| Well Name: LOBO 33/28 W00B FED COM | Well Location: T21S / R32E / SEC 33 / SWSE / 32.4283576 / -103.6770467 | County or Parish/State: LEA / NM |

Sundry ID: 2797675

Type of Action: APD Change

Procedure Description: Mewbourne Oil Company request that the following change be made to the Lobo 33/28 W00B Fed Com #1H (APD ID #10400062769): 1. Change name f/ Lobo 33/28 W00B Fed Com #1H (APD ID #10400062769) to Lobo 33/28 Fed Com #706H. 2. Change SHL f/ 150 FSL & 1810 FEL (33) to 150 FSL & 1760 FEL (33) 3. Request a variance to perform break testing and offline cementing per attachments. 4. Attached Break Testing and Offline Cementing variance & new plat.

Figure 3. Cactus 9 5/8" 5M offline cementing tool. Pressure rating limited by the lesser of 5M tool rating or the 9 5/8" pup joint and casing.

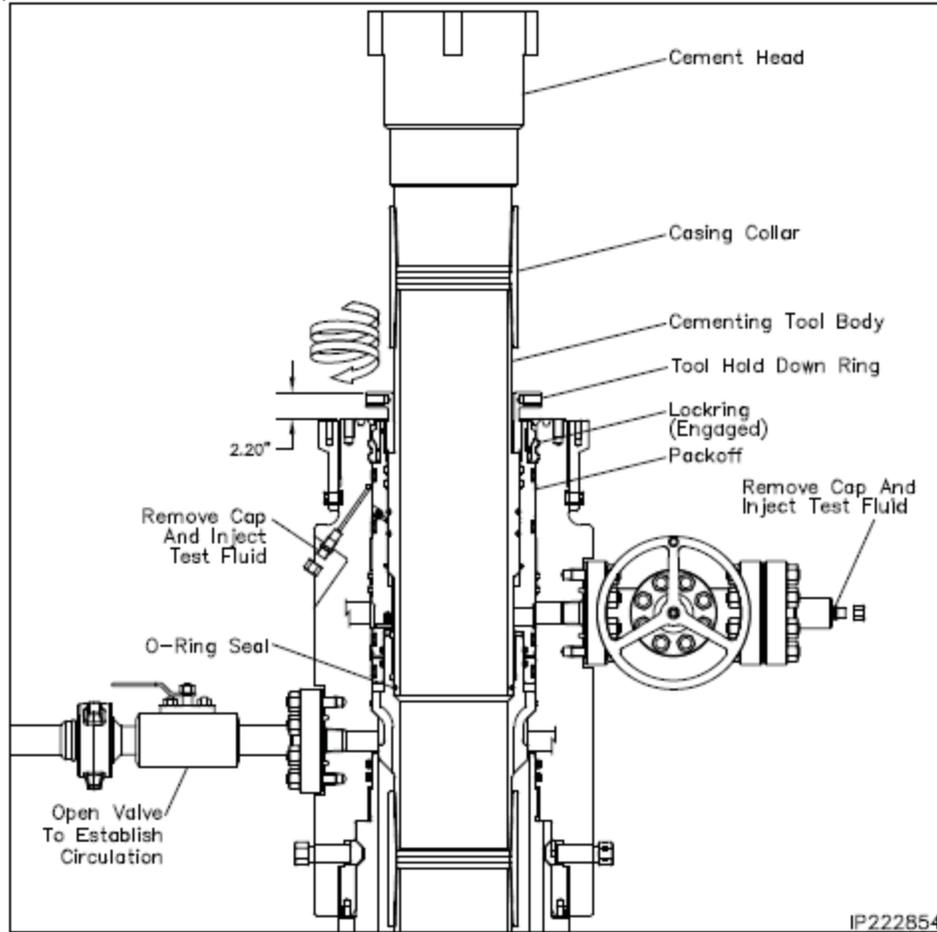
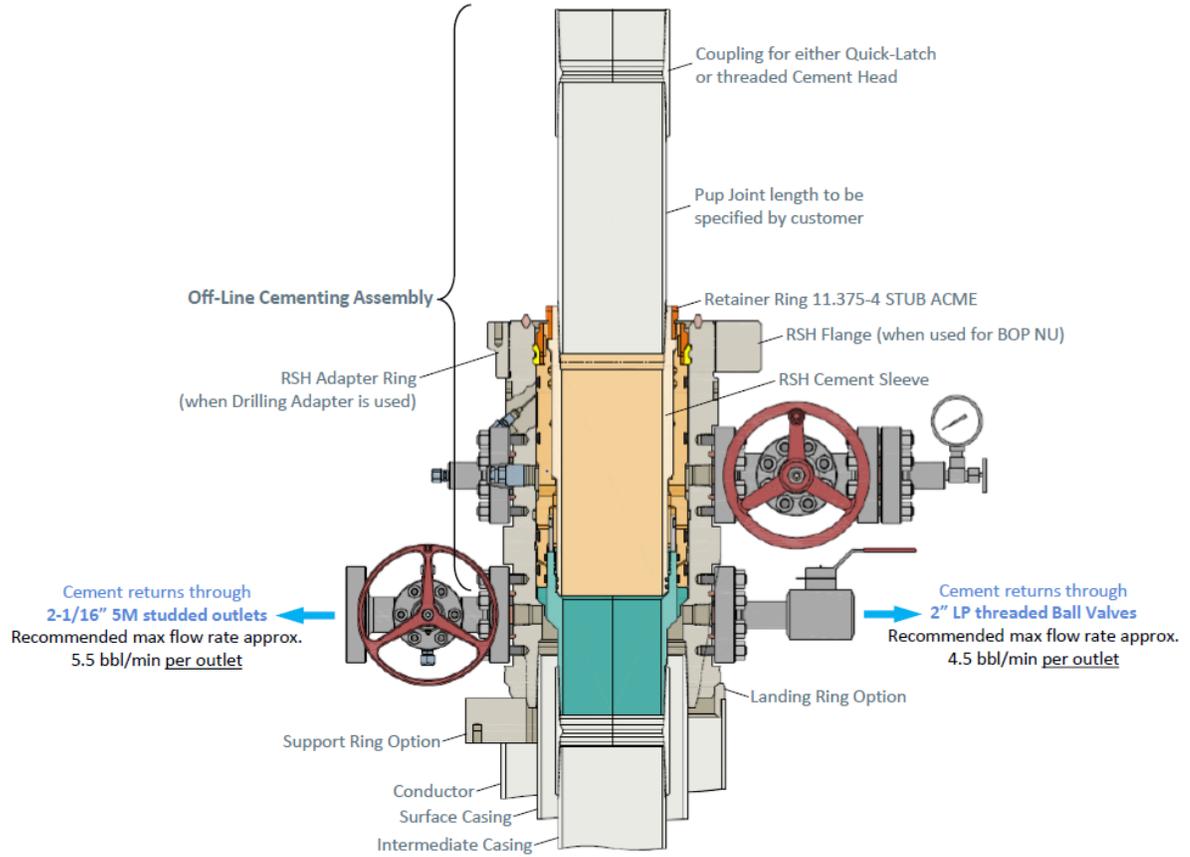
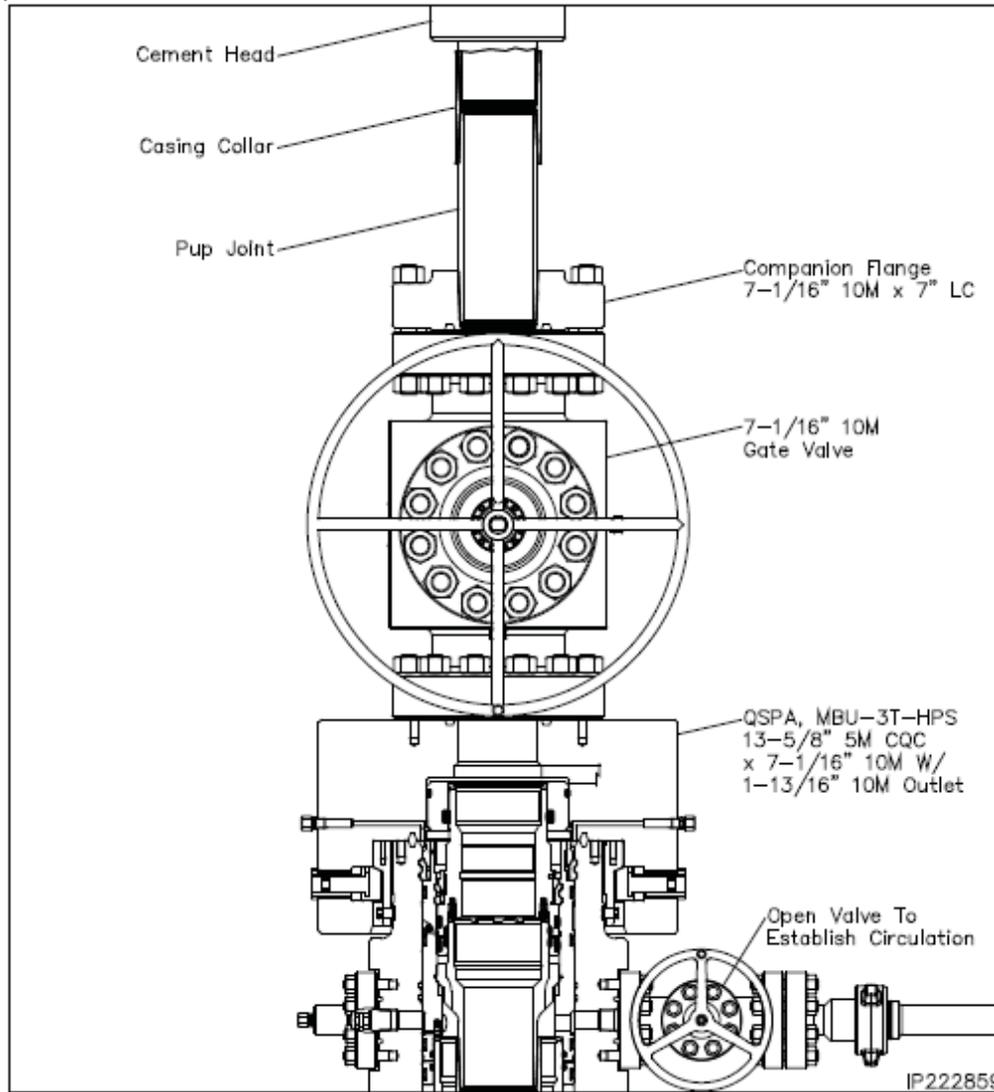
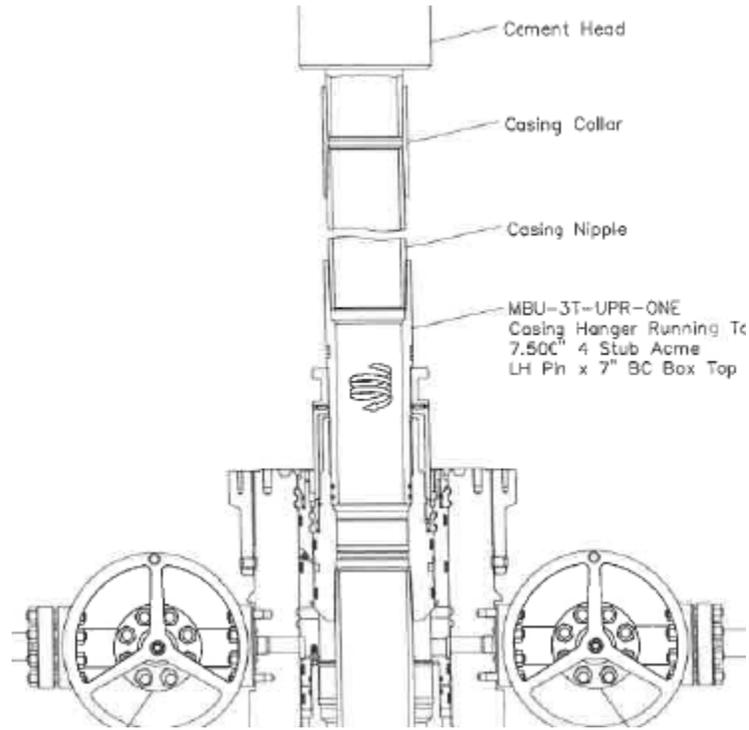
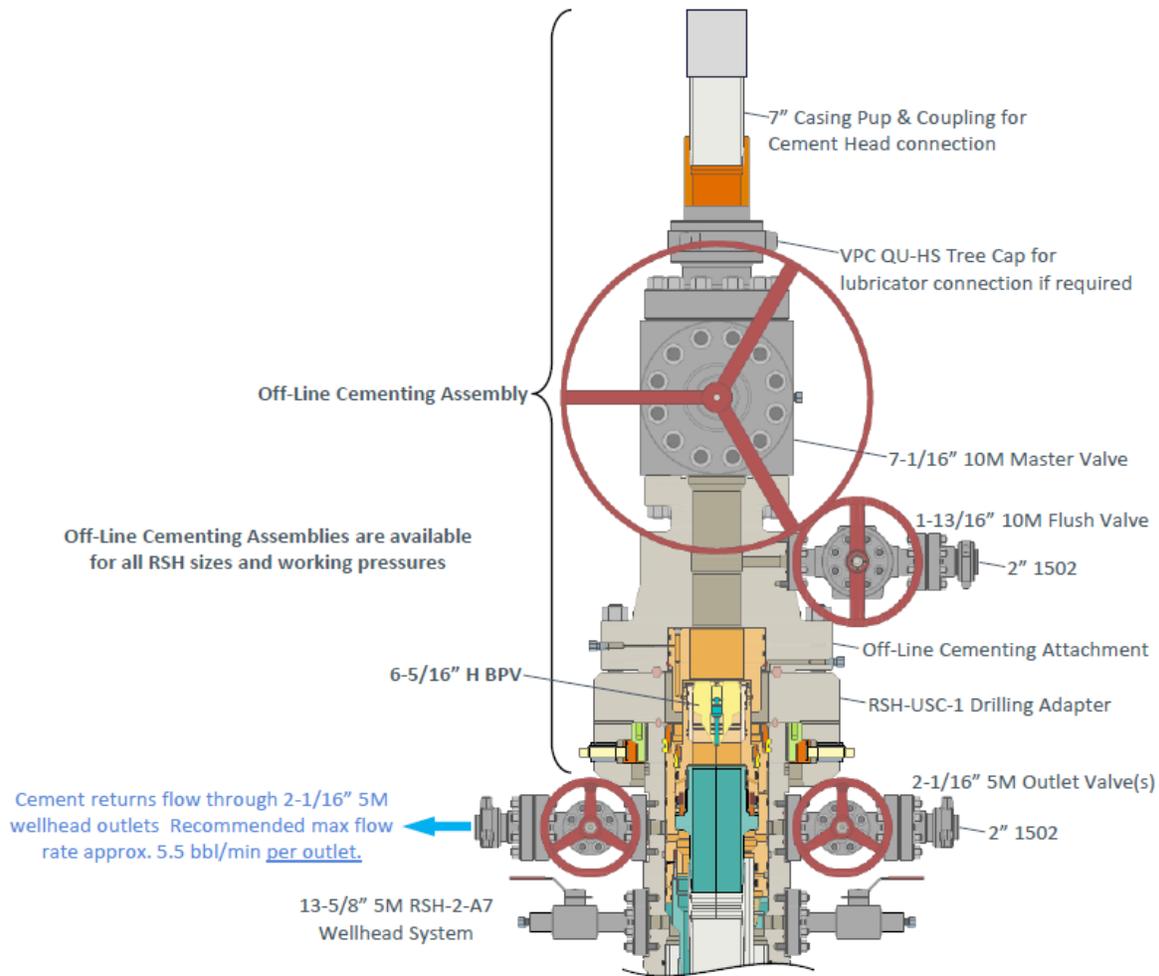
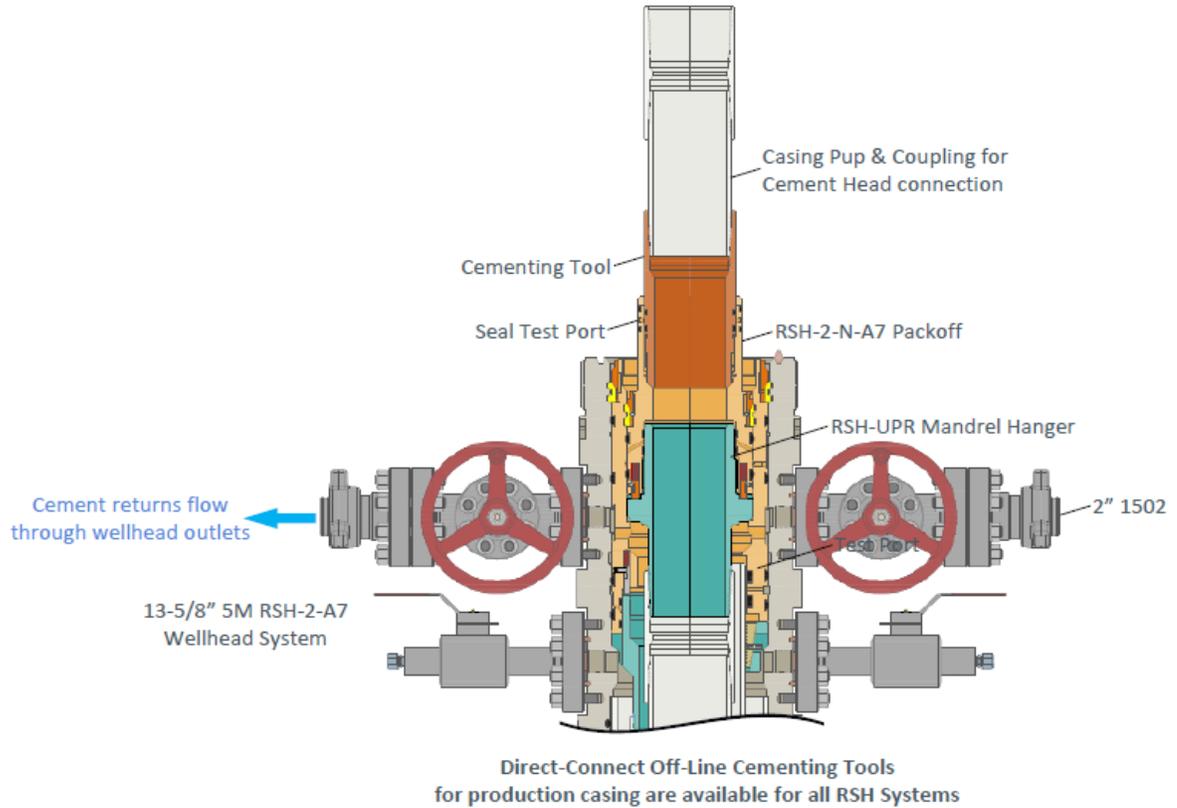
10. Make up offline cement tool using forklift per wellhead manufacturer (Fig. 3 - 8).
11. Make up cement head on top of offline cement tool.
12. Commence cement operations.

Operator has been (**Approved**) to pump the proposed cement program offline in the **Surface and intermediate(s) intervals**. Offline cementing should commence within 24 hours of landing the casing for the interval. Notify the BLM 4hrs prior to the commencement of any offline cementing procedure at **Lea County: 575-689-5981**.

Figure 9. Five valve 15k choke manifold.

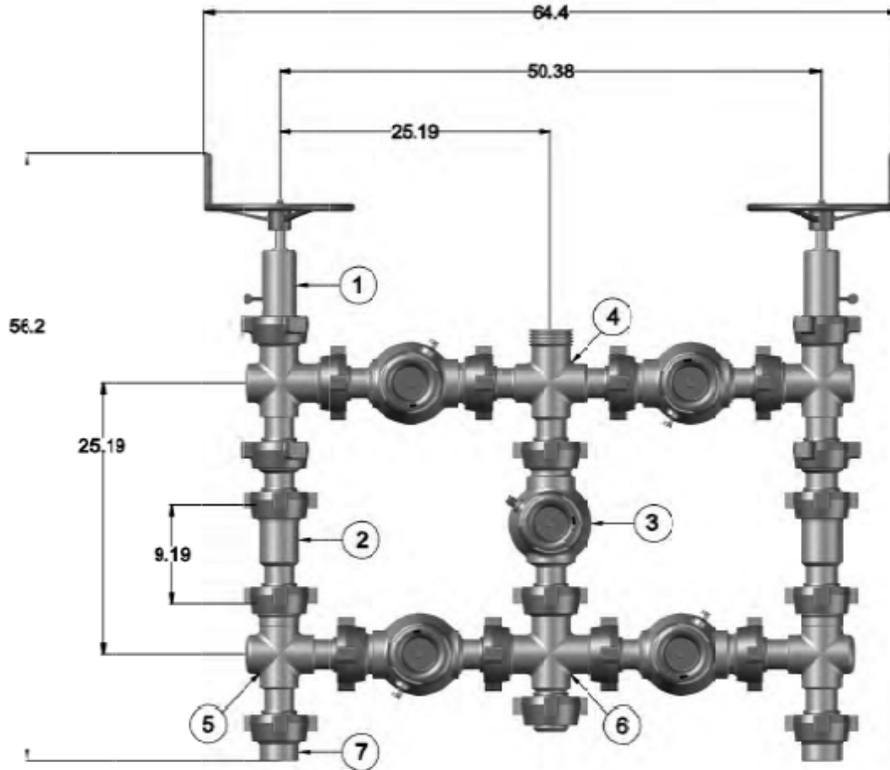
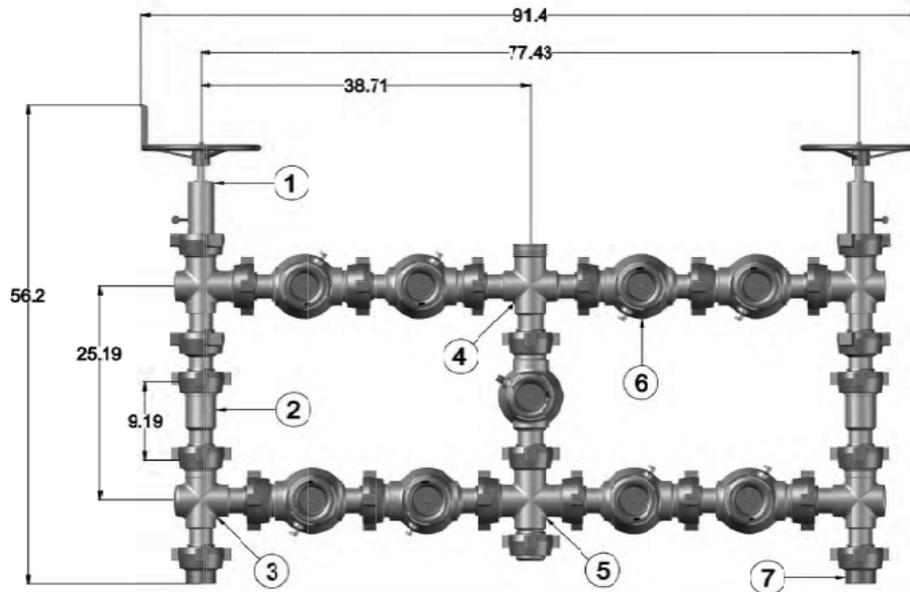
- Pressure build up in annulus before cementing
 - Contact BLM if a well control event occurs.
 - Rig up 3rd party pump or rig pumps to pump down casing and kill well.
 - Returns will be taken through the wellhead valves to a choke manifold (Fig 9 & 10).
 - Well could also be killed through the wellhead valves down the annulus.

WELL LOCATION AND ACREAGE DEDICATION PLAT

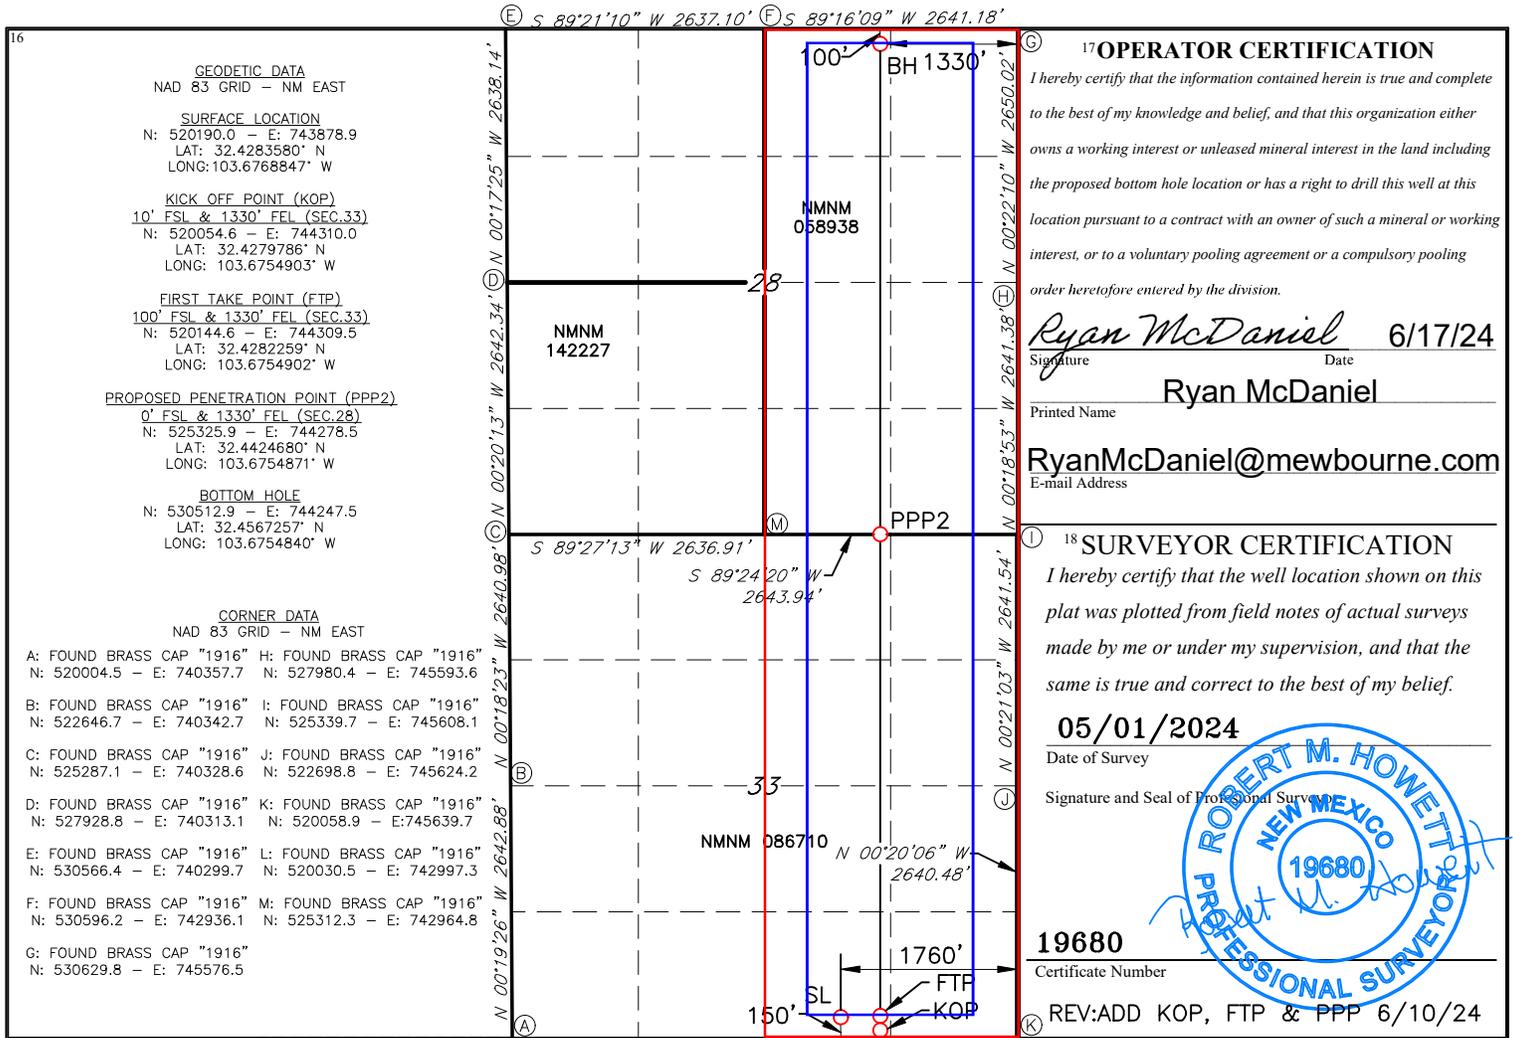
1. **Change name f/ Lobo 33/28 W00B Fed Com #1H (APD ID #10400062769) to Lobo 33/28 Fed Com #706H.**
2. **Change SHL f/ 150 FSL & 1810 FEL (33) to 150 FSL & 1760 FEL (33)**
3. **Request a variance to perform break testing and offline cementing per attachments.**
4. **Attached Break Testing and Offline Cementing variance & new plat.**

| UL or lot no. | Section | Township | Range | Lot Idn | Feet from the | North/South line | Feet From the | East/West line | County |
|---------------|-----------|------------|------------|---------|---------------|------------------|---------------|----------------|------------|
| 0 | 33 | 21S | 32E | | 150 | SOUTH | 1760 | EAST | LEA |

| UL or lot no. | Section | Township | Range | Lot Idn | Feet from the | North/South line | Feet from the | East/West line | County |
|---------------|-----------|------------|------------|---------|---------------|------------------|---------------|----------------|------------|
| B | 28 | 21S | 32E | | 100 | NORTH | 1330 | EAST | LEA |
